**ADDENDUM #3**

**Bid #09-11-12-04 "Hawthorne Terrace Water System Improvements"**

**BID NO. 09-11-12-04**  
**HAWTHORNE TERRACE WATER SYSTEM IMPROVEMENTS**  
**CONTRACT NO. 3 - MODIFICATIONS TO WELL HOUSES**  
**CITY OF DANBURY PROJECT NO. 03-17C**

**ADDENDUM NO. 3**  
November 8, 2011

*Typical Duplex Treated Water Piping for 2750, 2850 and 3150 Valves with No Raw Water Bypass Pistons*

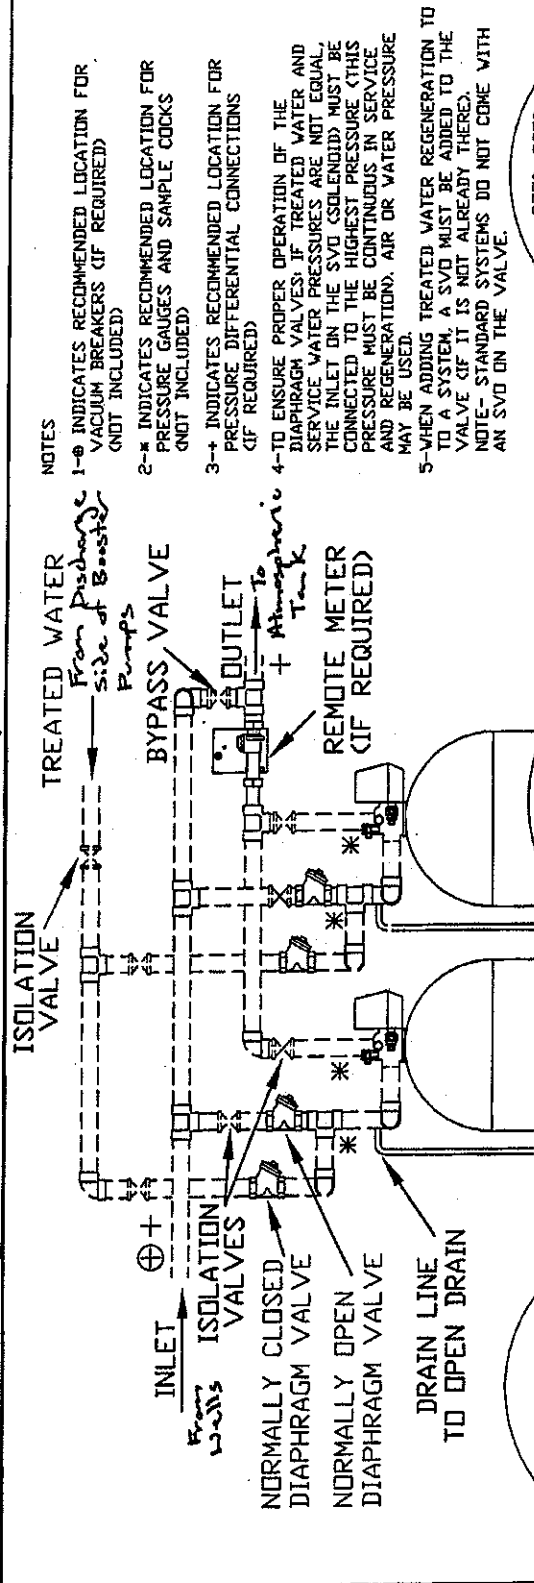
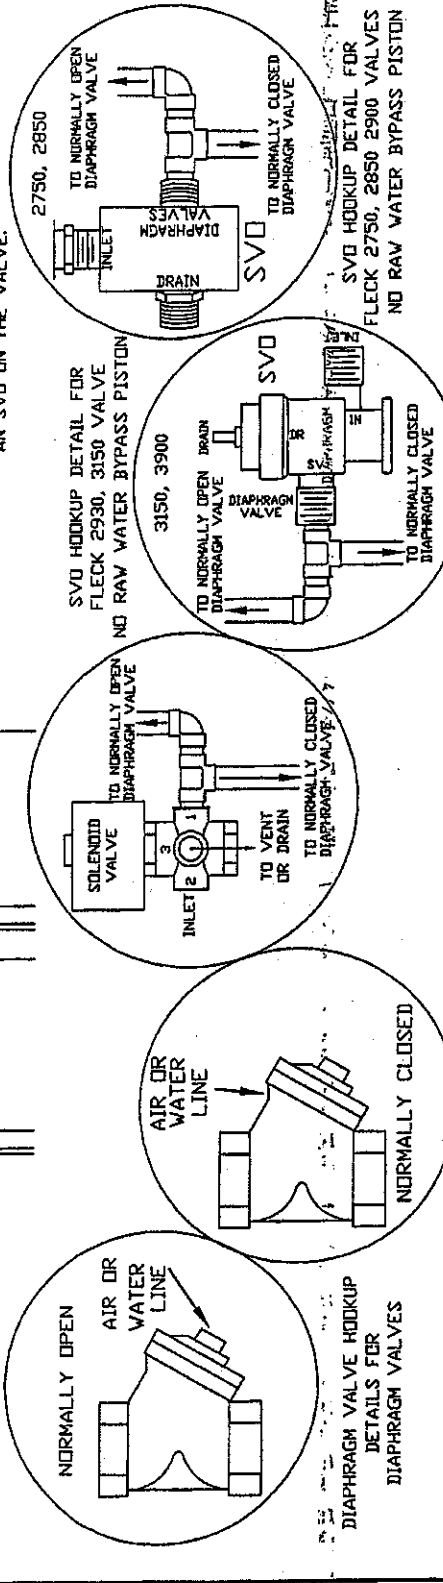
“2.8.25 Modifications to Calcite Filter Piping

The piping for the Calcite filters shall be modified as required to provide pressurized backwash water from the discharge side of the pumping station. A sketch of the additional piping required to provide pressurized backwash water for the Calcite filters is attached and made a part of this Addendum. The piping on the discharge side of the booster pumps, in the vicinity of the eyewash, should be connected to the pressurized backwash water inlet connection on each of the Calcite filter control valves. Control valves shall be modified or replaced with ones suitable for operating a pressurized backwash system. Piping and valves for the backwash water line shall be included for payment under Division 8, Piping and Valves. All conduits, wiring and connections to electrically operated valves shall be as recommended by the manufacturer and shall be included for payment under Division 12, Electrical Work.”

*This set-up brings pressurized water back to backwash*
